Access Compliance Report

Public Rights-of-Way

(Curb Ramps)

Intersection ID: 50320	Main Street: BRYN_ATHYN_CT	Cross Street: CINDY_LN	Location: SE
ADA ID: A928C4F8C2E3	Ramp Type: Directional1	Initial Pass/Fail: Pass	Overall Compliance: No
Severity Score: 2.75			
Codes/Mitigation Info/Possible Solution		Field Measurements/Component Compliance

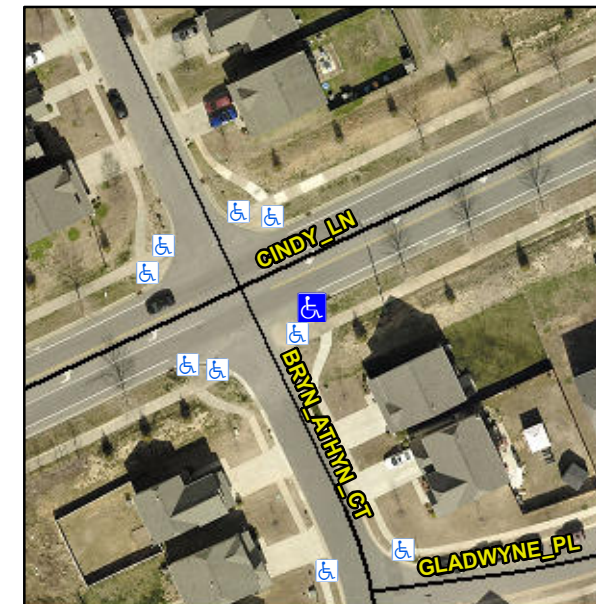
**Remove & Replace Entire Ramp.
Remove & Replace Gutter.**

**R304.2.2-Perp, R304.3.2-Para,
R304.5.3, R305.1.4, R305.2**
